Keithley Instruments  
28775 Aurora Road  
Cleveland, Ohio 44139  
1-800-935-5595  
[tek.com/keithley](http://tek.com/keithley)

This firmware is used on the following Keithley Instruments product models:

- Model 2461 System SourceMeter® Instrument
- 2461-NFP
- 2461-RACK
- 2461-NFP-RACK

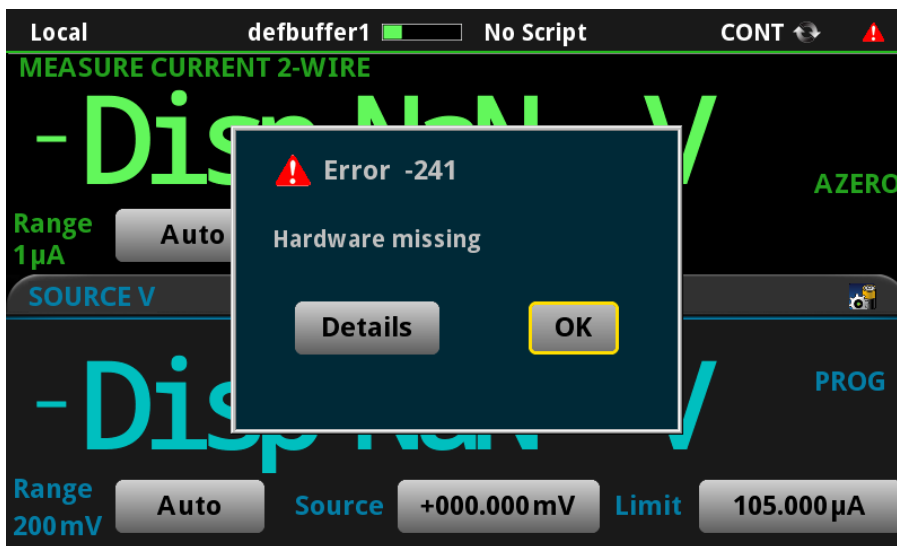
PR61502 From a cold power up, the Model 2461 SMU will sometimes fail with the following error message and will not operate properly.

If this issue occurs, a subsequent power cycle will allow the instrument to power up properly.

This issue has been corrected with firmware revision v.1.6.5.
